Programed Repairs Engines 601, 602, 603 Mechanical III

03 Pistons

03 Crankshaft radial sealing ring

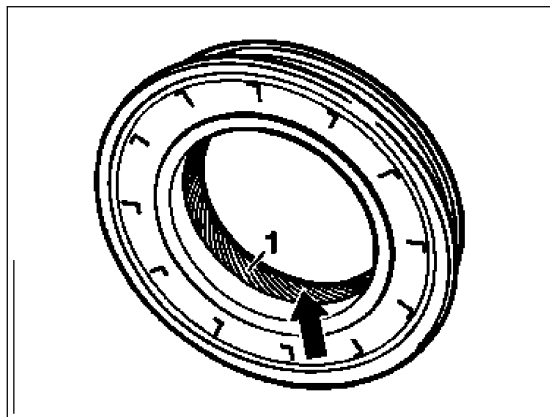
Replacing front crankshaft radial sealing ring.

If oil leakages occur at the front of the crankshaft, it is only necessary in the most frequent cases to replace the crankshaft radial sealing ring. Replacing hub at the same time is only necessary in those cases where two wear tracks (grooves) are visible on the hub. For hubs which have only one wear track (groove) a radial seal with a sealing lip offset 2 mm to the rear is available (repair version). If the sealing surface of the hub is only ground bright, only the standard version of radial seal may be fitted.

Press the radial seal dry (without grease) into the timing case cover and coat the sealing lip (Fig., item 1) with engine oil - do not use grease.
